**LEBANON PLANNING BOARD
SEPTEMBER 13, 2021 - 6:30 PM
COUNCIL CHAMBERS, CITY HALL OR
REMOTE VIA VIRTUAL PLATFORM
LEBANONNH.GOV/LIVE**

**Mason Storage, LLC,
38 Spencer Street
(Tax Map 78, Lot 39),
Zoned LD
PB2021-13-SPR**

Staff Memorandum – PB2021-13-SPR – *continued from 8/9/21*

Mason Storage, LLC, 38 Spencer Street (Tax Map 78, Lot 39), zoned LD: Request for Site Plan Review to construct a 15,000 sq. ft. addition to an existing warehouse building. PB2021-13-SPR

SU-30 Loading Exits: All Loading Docks

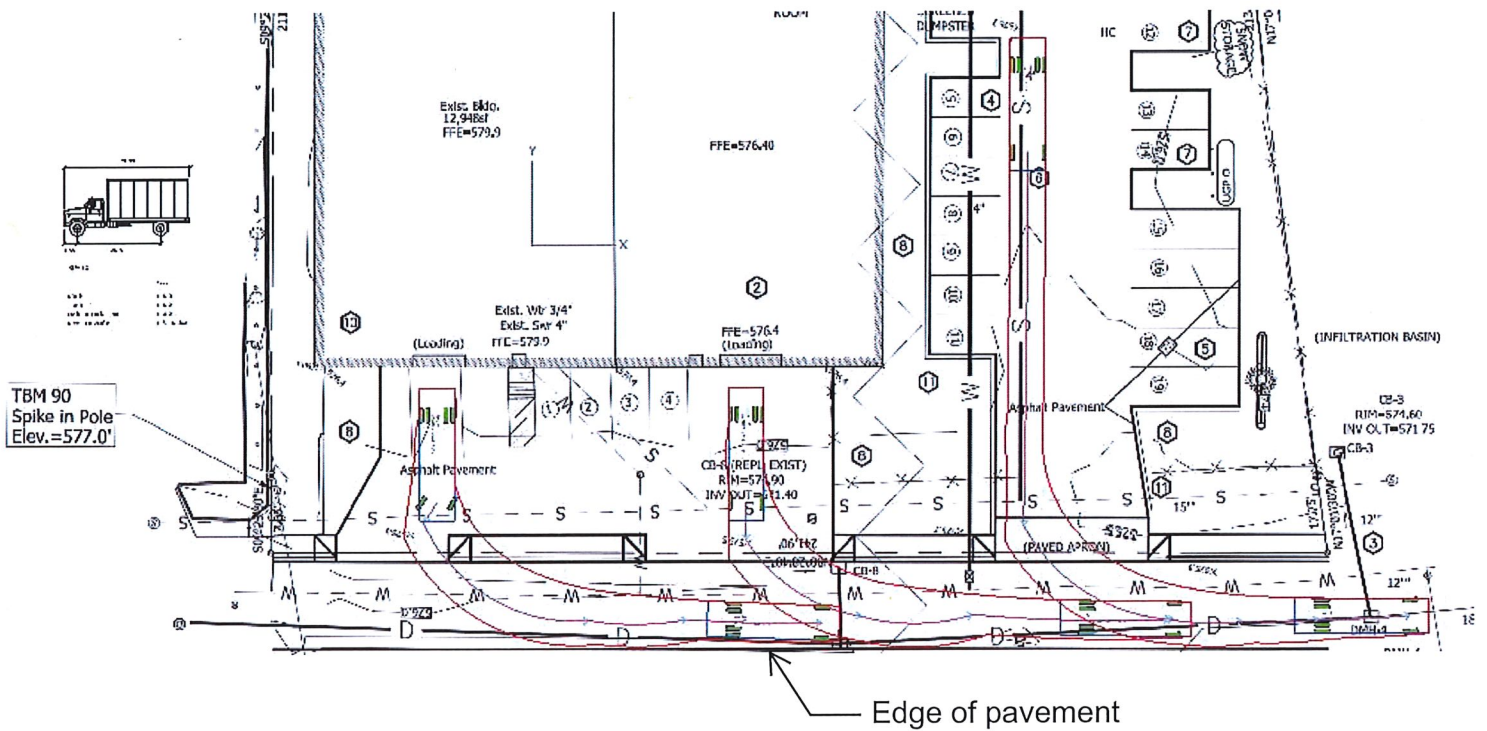
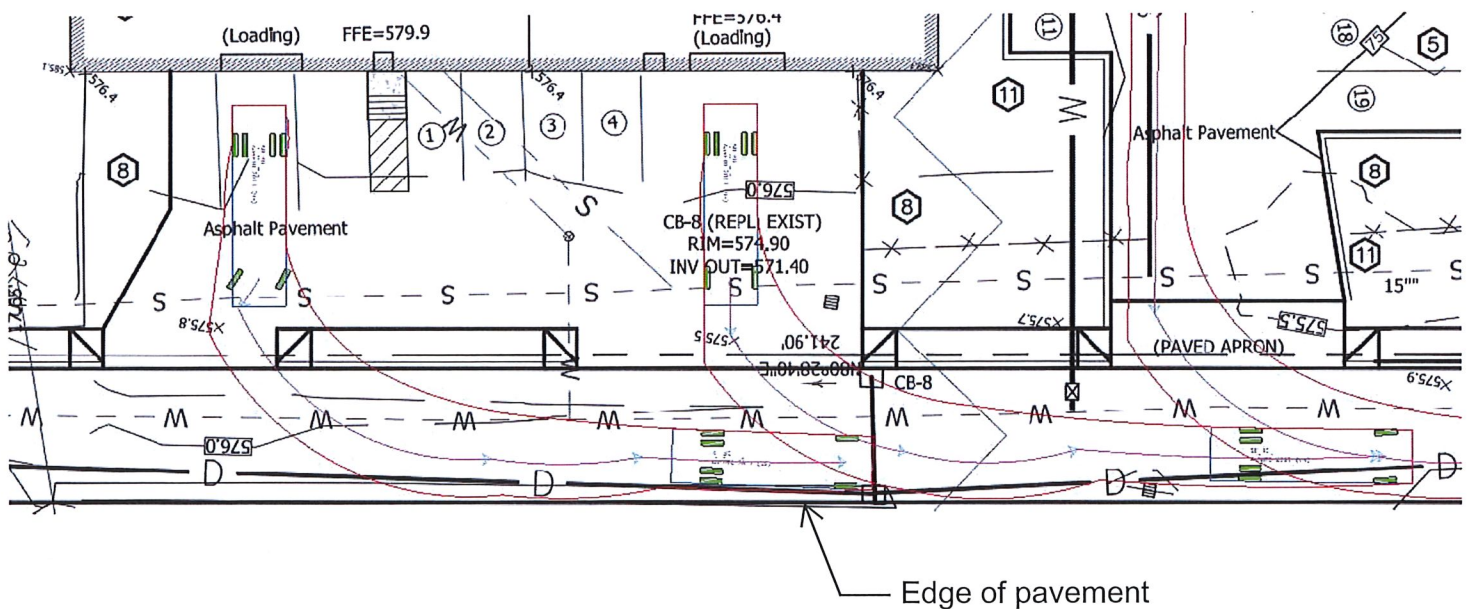
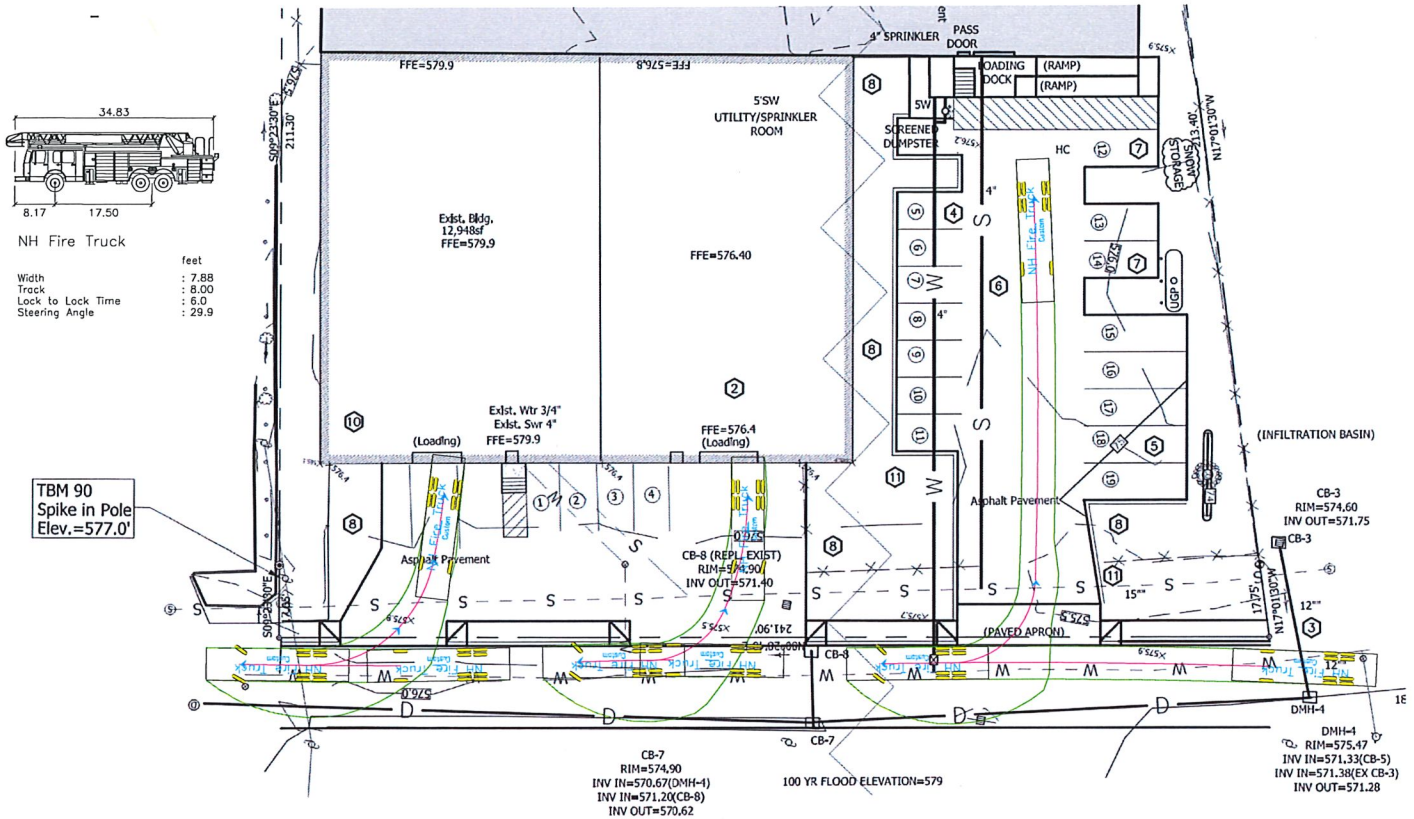
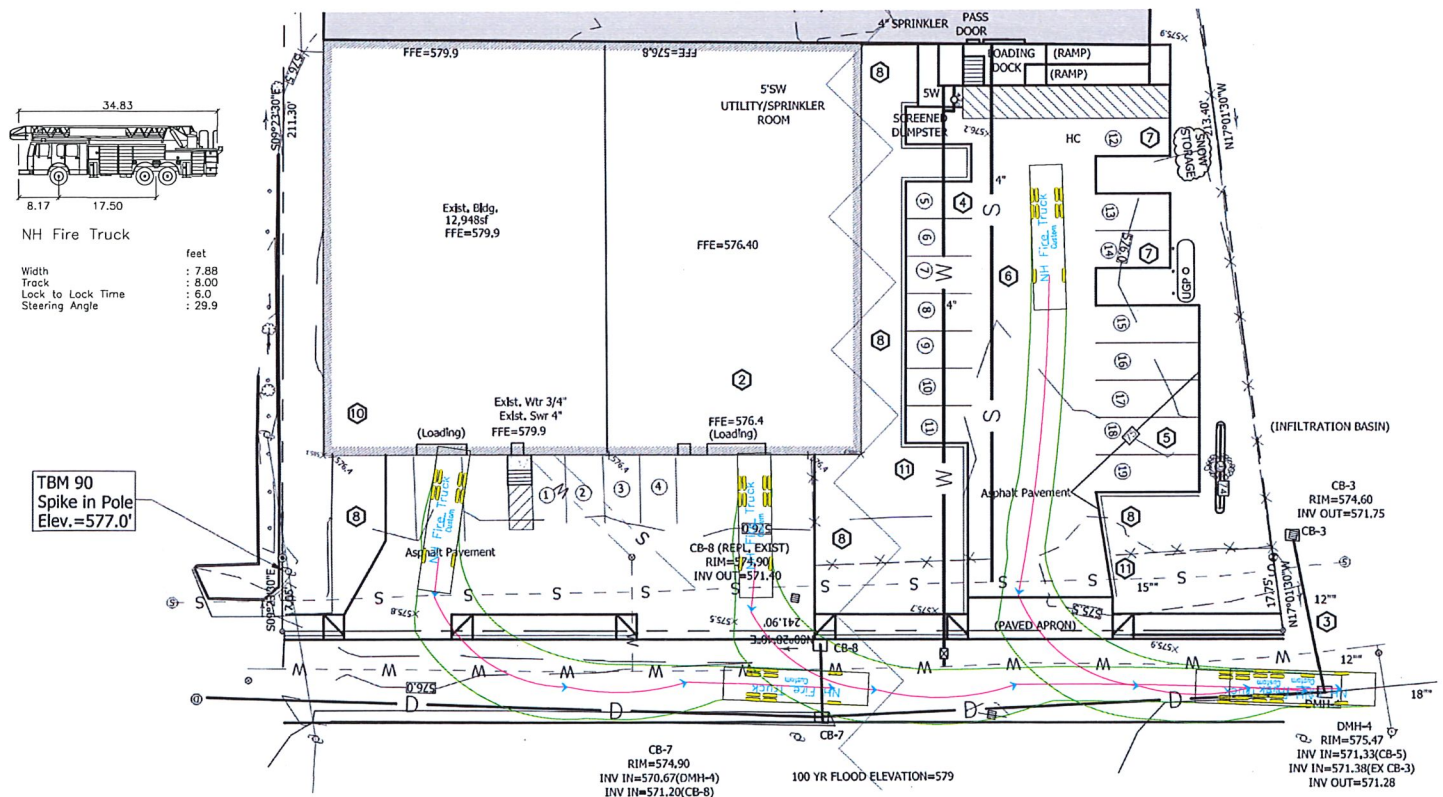
Staff Comment	Staff Notes
7	The vehicle turning analysis prepared by Corey Mack, WCG, dated August 23, 2021, appears to be a computer-generated model. Staff requests that the applicant identify the model software used, methodology, assumptions, discussion, results and conclusions.
9	The plans should identify the water service pipe types. In addition, the domestic water shutoff valve should be located within the City's right-of-way.
12	The Applicant's engineer has noted that proposed temporary erosion control measures are shown on Sheet C-3. However, there do not appear to be any temporary erosion control measure details shown on the detail sheets.

1. The turning plans provided for the proposed addition are inadequate; the International Fire Code (IFC) requires that the specifications for the City's fire apparatus are used (whereas the turning plans submitted utilize a moving truck).

This is a pointless exercise as there is essentially no areas for the fire vehicles to maneuver. No responsible Fire Chief is going to deploy a \$0.5million vehicle this close to a building on fire. However, we have prepared the simple movements to the loading dock for moving vehicles and the movement plans for fire vehicles, should they wish to back into the site, or maneuver around the front service area.

FIGURE 2 – E-ONE HR-100 FIRE TRUCK TURNING INTO NORTHERN PARKING

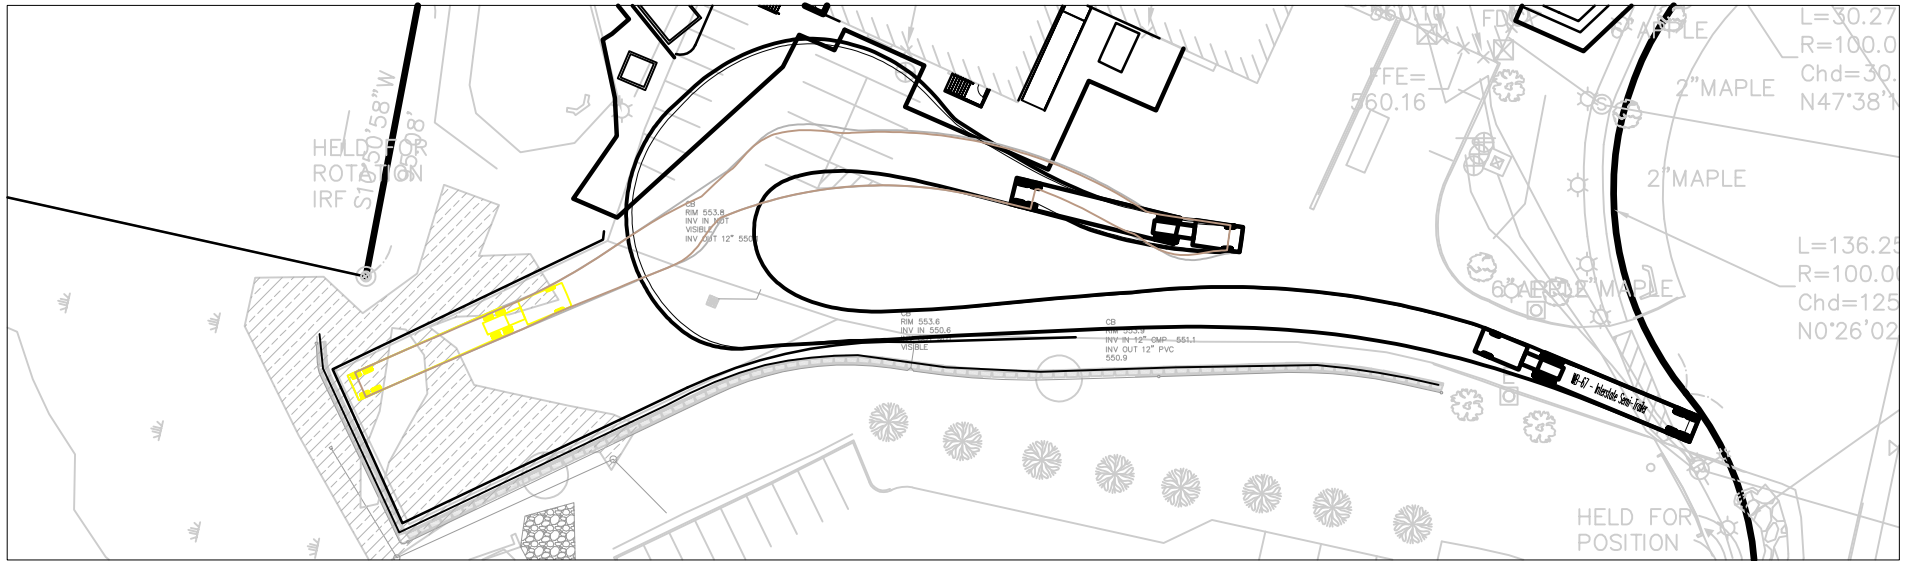
6. **COMMENT:** Provide emergency vehicle turn radius diagrams as requested by the Fire Department (5.1.E.24)
- RESPONSE:** Autoturn data for E-ONE HR-100 fire truck has been provided for the northern parking area under supplemental Figure 2.

RESPONSE: Autoturn data for has been provided for the northern parking area as supplemental Figure 2.
